**ZONING COMMISSION
District of Columbia**

CASE NO. 94-01A

Re: Zoning Commission Case No. 94-01A
1331 L Street, NW
Modification to Approved Planned Unit Development

**A PLANNED UNIT DEVELOPMENT MODIFICATION
SUBMITTED TO
THE ZONING COMMISSION FOR THE DISTRICT OF COLUMBIA
BY 1331 L STREET NW, L.P.
01 JUNE 2006**

A-2

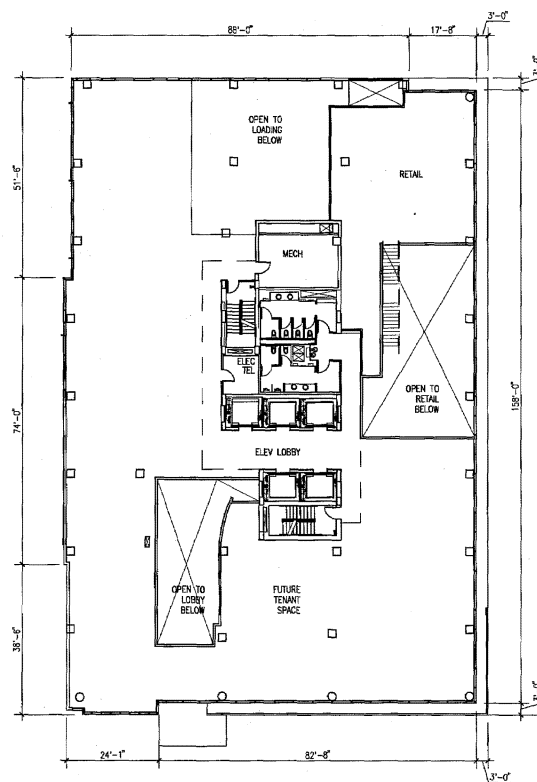
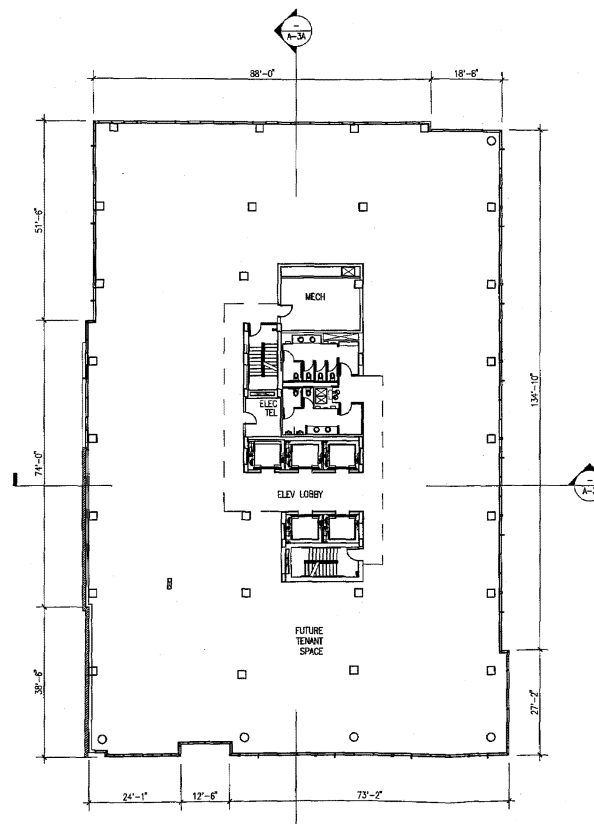
<u>Sheet No.</u>	<u>Comments</u>
A-0	• Date changed to 06.01.06 (shows on all drawings).
SP-1	• Drawing now shows penthouse plan, not penthouse roof. • Penthouse setbacks dimensioned. • Dimensions updated to reflect perimeter articulation. • Penthouse expanded, uses identified, enclosed/unenclosed spaces identified. • Roof of 1341 L Street modified.
SP-2	• Modification to building footprint at south facade by way of one additional retail entrance. • Introduction of fire control room. • Introduction of health club at northern portion of west retail space. • Development of lobby to show security desk. • Development of loading, trash and parking ramps (location remains unchanged). • Refinement of existing conditions of surrounding buildings (1341 L).
A-1	• Parking levels developed. • Additional parking level shown, increasing total parking spaces to 114 (shown in chart).
A-2	• Second Floor plan shows relocation of two story retail from west to east. • New retail at second floor in northeast corner. • Typical floor shows developed articulation of perimeter wall - elimination of notches at east and west facades, setback at northeast corner. • Dimensions updated accordingly.

Project Number **A-3**

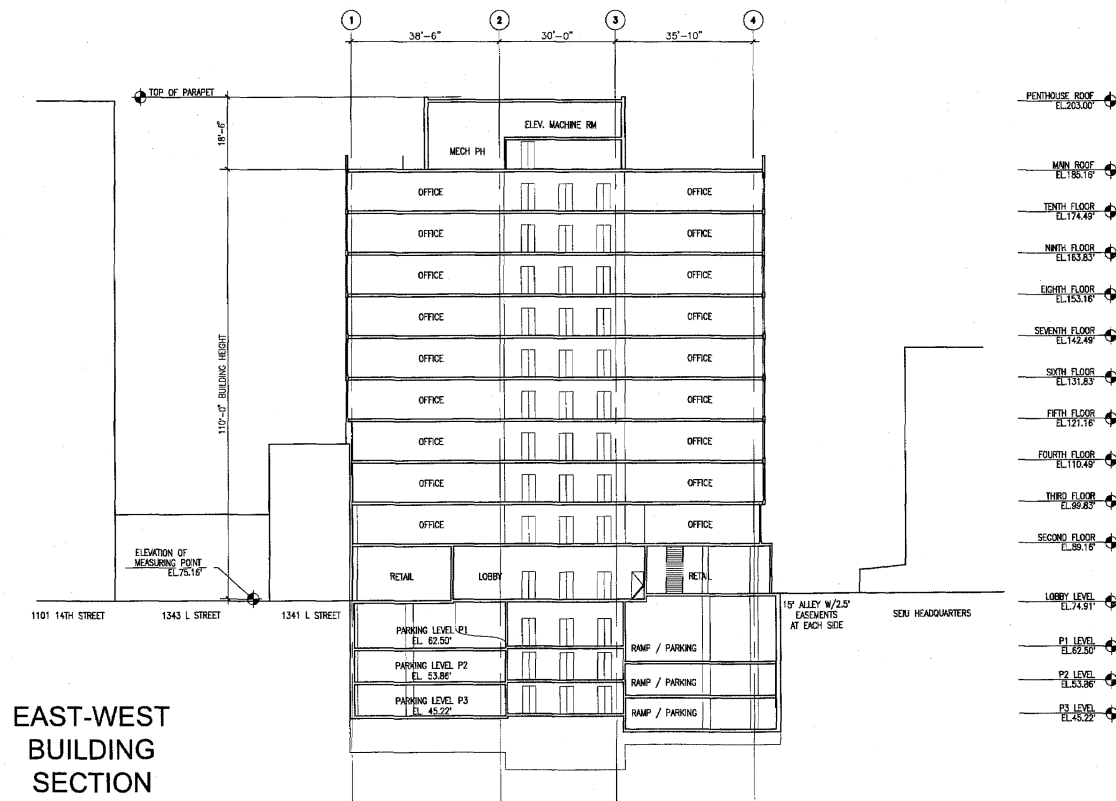
A-3	• Revised section to show parking level modification.
A-3A	• Revised section to show modifications lobby level change. • Revised penthouse structure (enclosed and unenclosed spaces) illustrated.
A-4	• Tower element reduced in height by 2' and reduced in width by 2'-6". • Lobby level measurement modified. • Retail storefront modified to show increased glass area. • West retail modified to express one-story retail in lieu of two-story.
A-5	East Elevation – • Vertical low E accent glass reveal eliminated. • Window expression along first floor alley refined. West Elevation – • Tower element reduced in width. North elevation – • Precast above loading access modified. • Building controlled lighting featured slightly reduced in width. • Parking/loading access revised.
SP-3	• Streetscape plan modified to show one additional storefront entry. • East-West section/elevation modified to show new south elevation.

SP-3

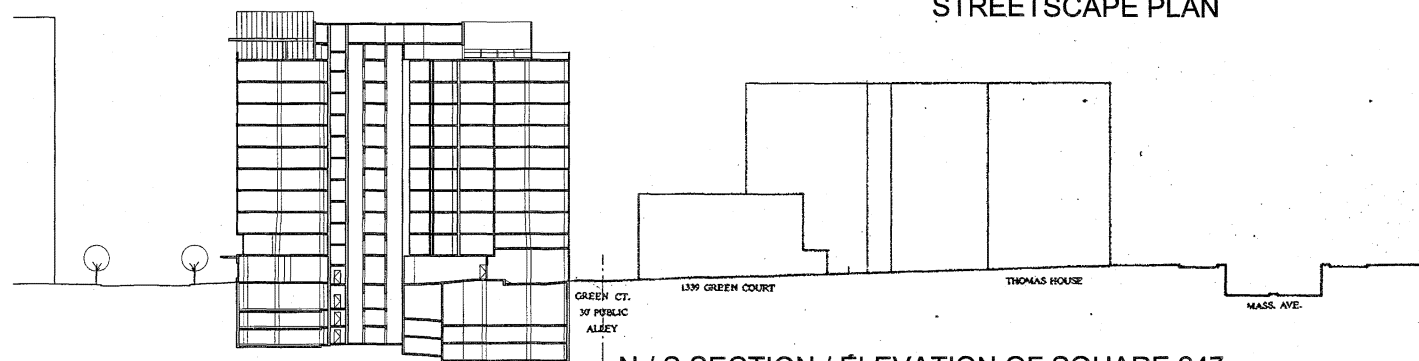
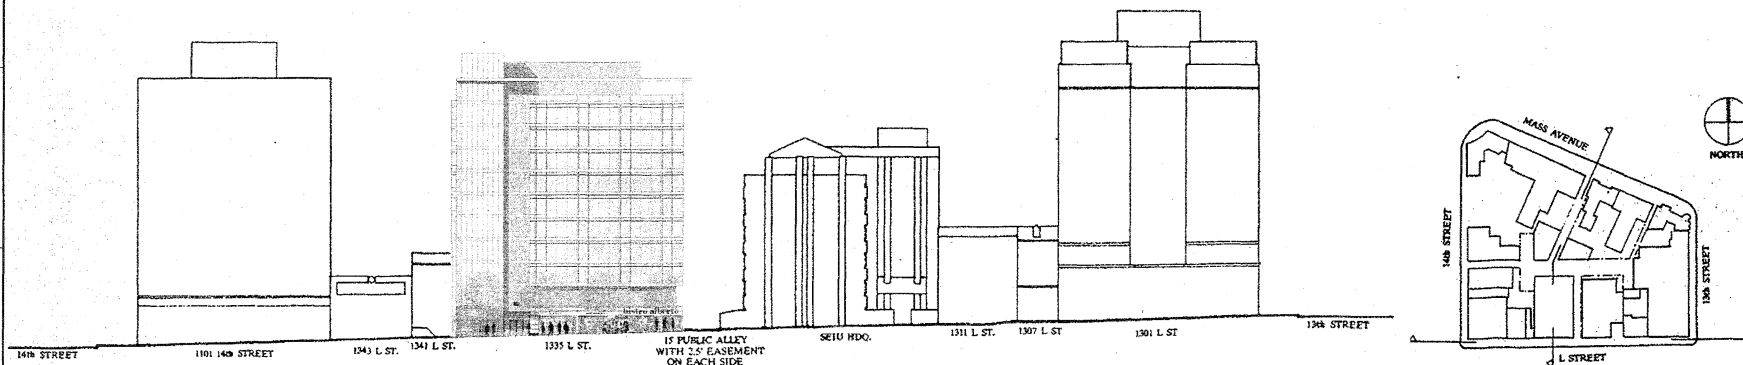
While the rooftop embellishment is intended to enliven the overall design of the project and to call attention to the building, it will do so only in the localized context of the 1300 block of L Street, NW, of the project site. Commissioner Parsons has raised questions as to the visibility of the rooftop embellishment from distant vistas, especially the monumental core. Importantly, and in contrast to buildings with tower embellishments found elsewhere in the District, the proposed building is not located at an intersection of streets, nor does it confront any park, reservation, or other public space. Also within the context of the surrounding neighborhood the project site is surrounded to the west, south and east with taller buildings that visibly block the view of the proposed roof top embellishment from beyond the immediate vicinity and clearly from the monumental core of the District. (See Exhibit A, *Sheet SP-3*).
